May 31, 2000  
NRC-00-0042

Subject: Response to Request for Additional Information  
on Technical Specifications Change Request Related to  
Spent Fuel Pool Expansion at Fermi 2 (TAC No. MA7233)

**RESPONSE TO REQUEST FOR ADDITIONAL INFORMATION ON FERMI 2  
RERACK LICENSE SUBMITTAL**

Stress-Strain Curves for concrete subjected  
to triaxial compression \*

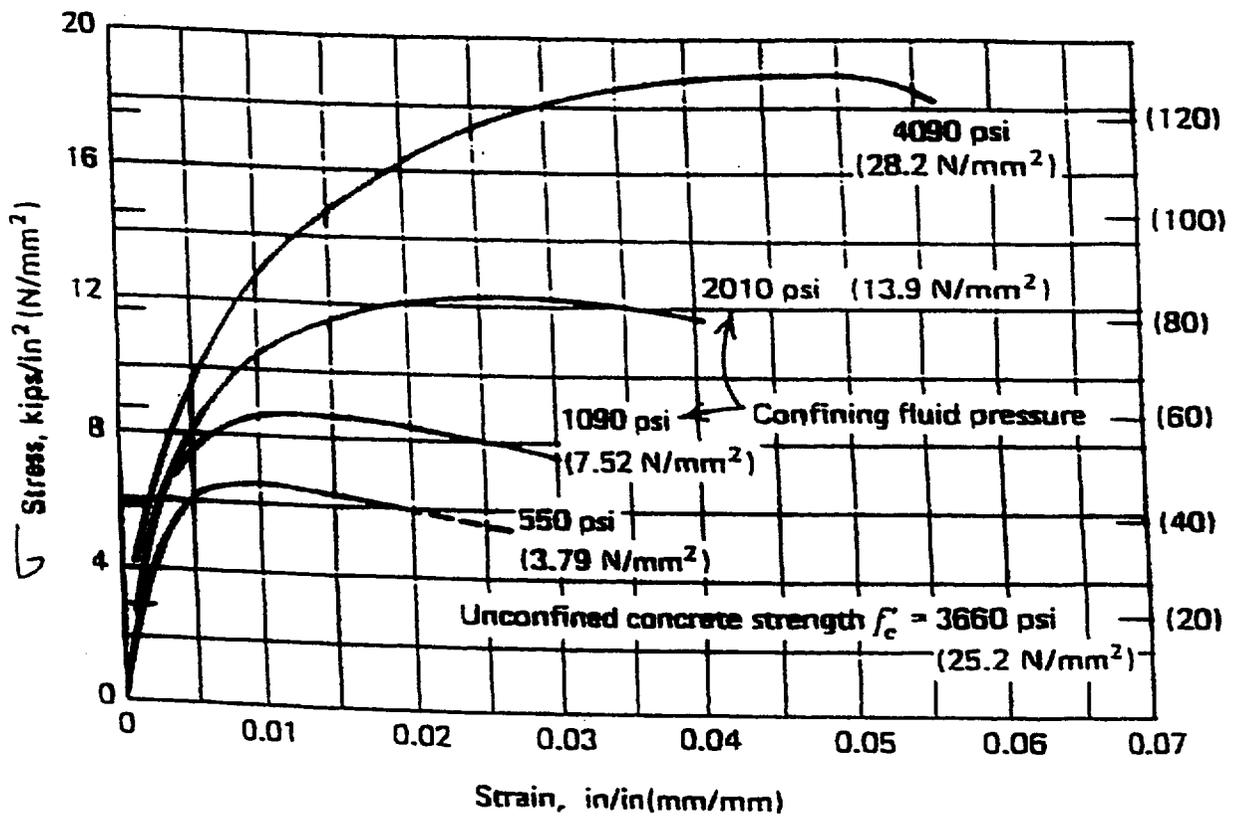
Section 7.5.3 "Deep Drop Event" in Enclosure 4 states that the maximum compressive stress in the concrete slab for a rack deep drop accident is 8.3 ksi, which is larger than the concrete compressive strength of 5.9 ksi. Under such conditions, explain the basis for your conclusion that substantial damage to the pool slab is not indicated.

The conclusion that the concrete slab sustains a localized crushing is based on a conservative assumption. The analysis conservatively uses a static compressive strength of the concrete, i.e., 5.9 ksi, as the failure limit of the concrete for a dynamic event such as the deep drop. In fact, the concrete failure limits for a dynamic event should be much higher than the static limit, as suggested by many credible textbook references. With regards to Fermi 2 spent fuel pool structure, the upper stratum of the pool slab supporting the stainless steel liner, which is laterally confined and simultaneously compressed from the interior of the pool water pressure, exhibits a triaxial compressive stress behavior, which reduces the tendency of internal cracking. This suggests that a stress-strain curve, which can accurately represent the triaxial behavior of the concrete slab, would be more appropriate for this analysis. Attachment 1 provides a plot of stress-strain curves for concrete subjected to triaxial compression, which has been taken from Park and Paulay's text (Reference 1). This stress-strain plot has been used as input in the drop accident analyses for several different nuclear plants including Union Electric's Callaway Plant, Wolf Creek Plant and Commonwealth Edison's Byron and Braidwood plants. Based on this plot, the concrete failure stresses are much higher than the unconfined compressive strength of 5.9 ksi. For example, A.M. Neville's textbook, "Properties of Concrete", (Reference 2) gives a failure stress of 14,700 psi for 3,500 psi concrete, which is consistent with Park and Paulay (Reference 1).

Therefore, although the concrete failure limit is much higher than 5.9 ksi, a conservative conclusion that the concrete slab is locally crushed was made in Section 7.5.3 of the Licensing Report based on the unconfined static compressive strength 5.9 ksi.

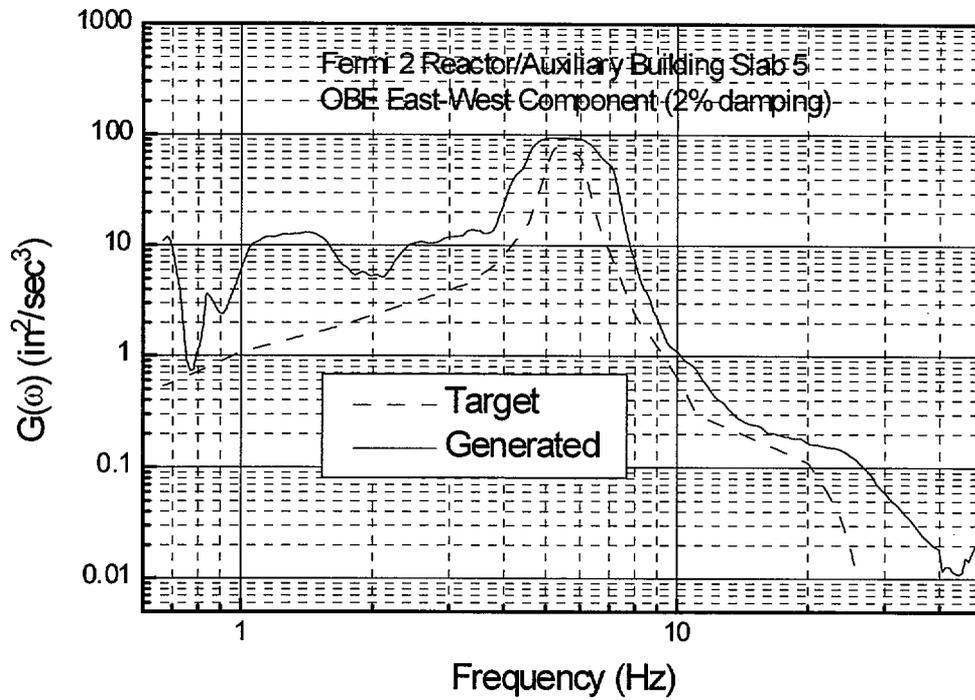
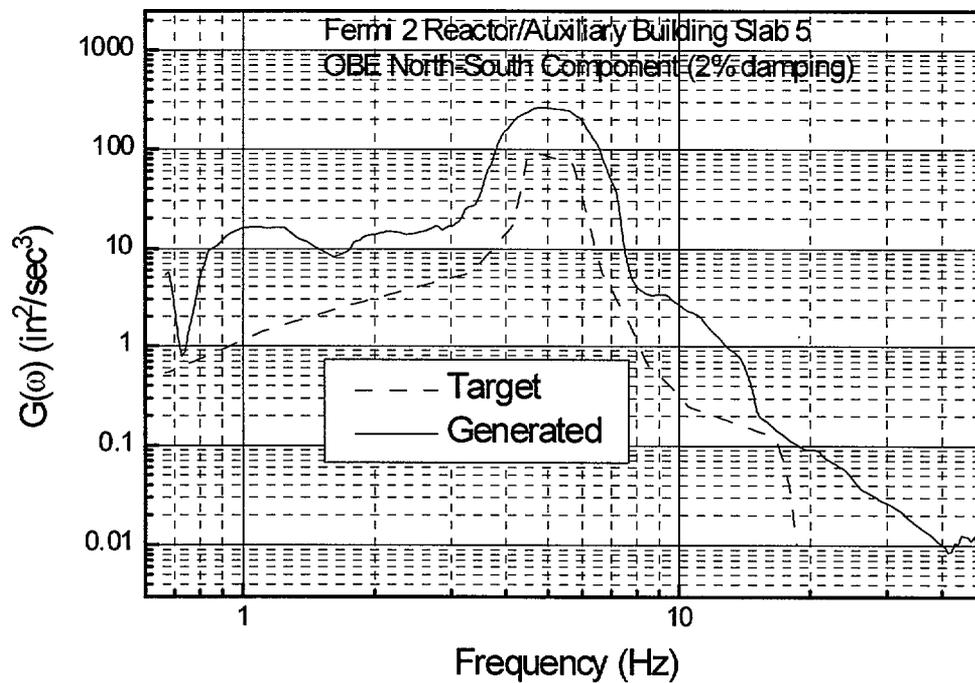
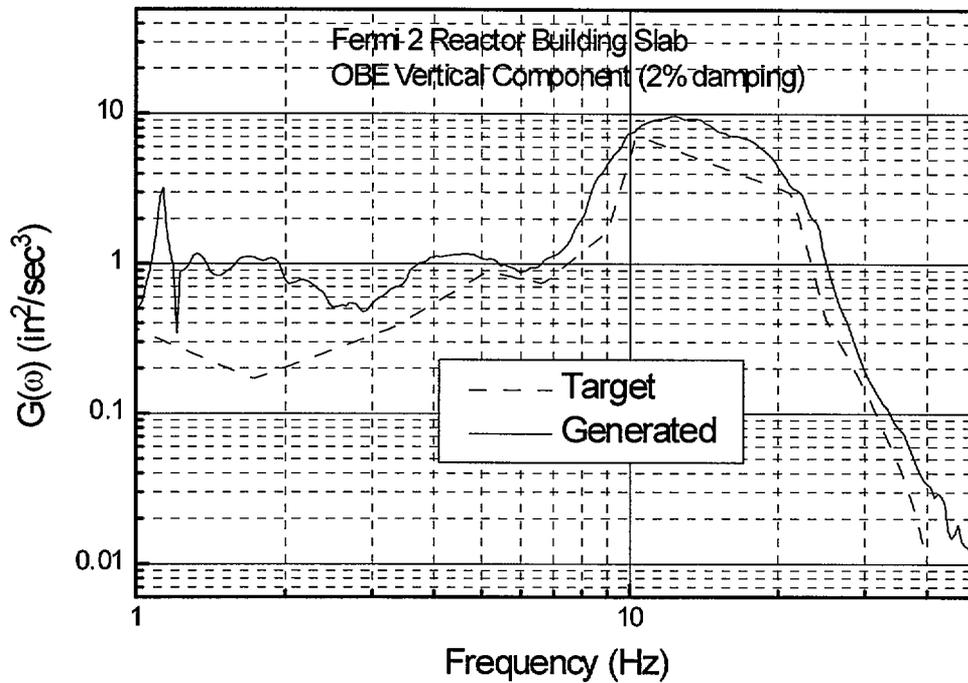
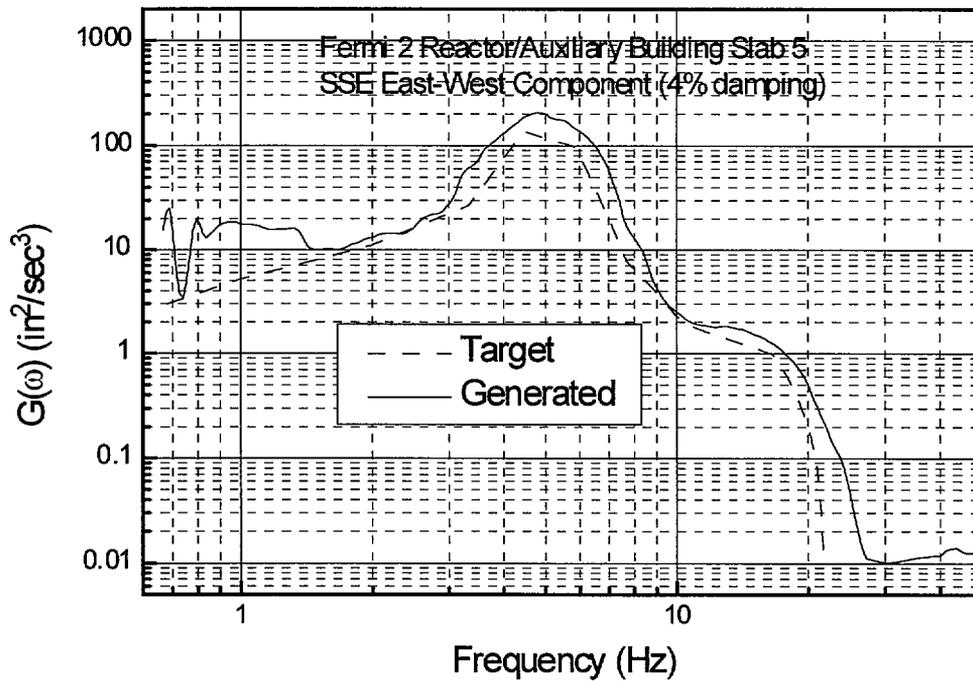
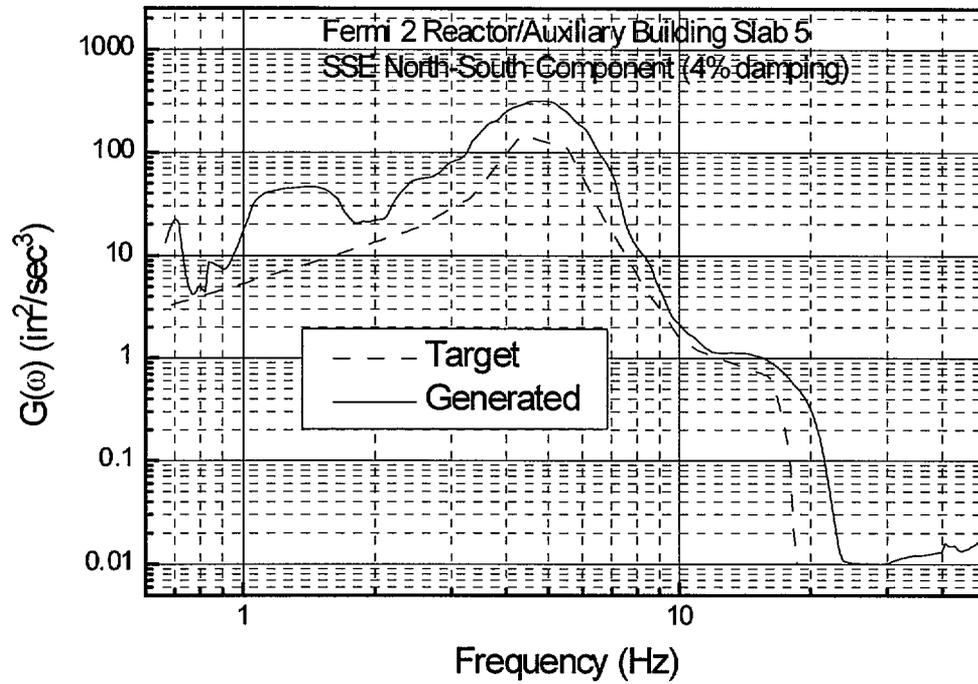
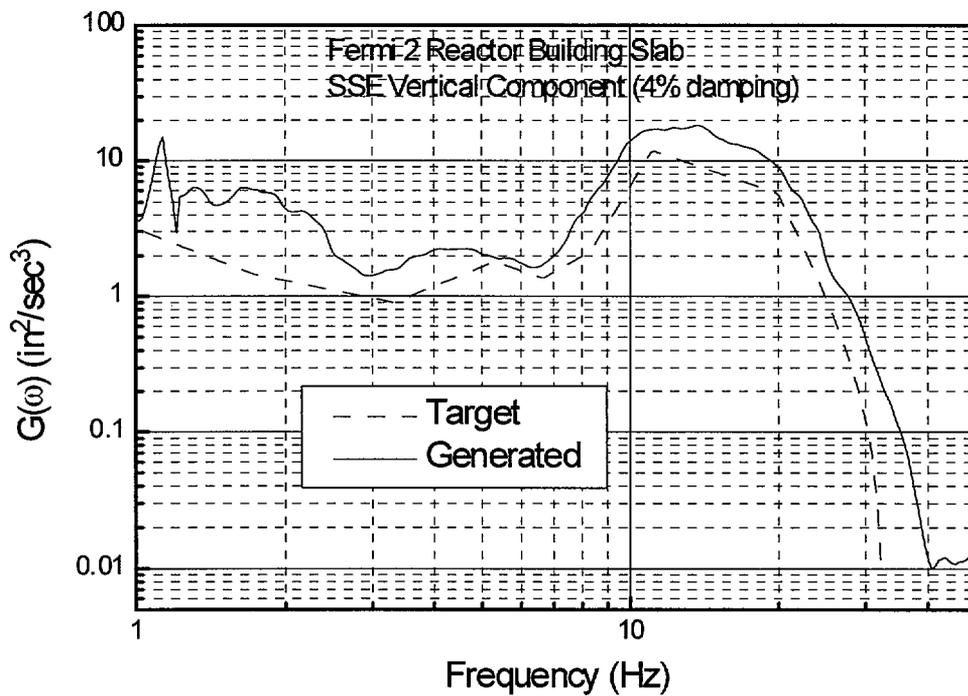
- (a) Explain how the target (design basis) response spectra (refer to in Section 6.4) were obtained. Also demonstrate that the synthetic time histories used in the analyses satisfy the power spectral density (PSD) requirements of SRP 3.7.1.
- (b) Provide the analysis results that show that the design criteria related to kinematic stability (i.e., safety factors against rack overturning) described in Chapter 2 of Enclosure 4 have been satisfied. Also, provide the dimensions of the gaps between the racks, and between the racks and the spent fuel pool (SFP) walls.

Two sets of artificial time histories were used in the structural analyses: a Safe Shutdown Earthquake (SSE) and an Operating Basis Earthquake (OBE). These synthetic time histories are statistically independent with their cross correlation coefficients less than 0.15. Furthermore, they satisfy the response spectrum and PSD enveloping requirements of SRP 3.7.1. Figures 1.1 through 1.6 provide a comparison of the PSD curves associated with the generated time histories and the PSD curves associated with the design basis response spectra. These figures clearly show that the generated PSD curves envelope the target curves over the entire frequency range.
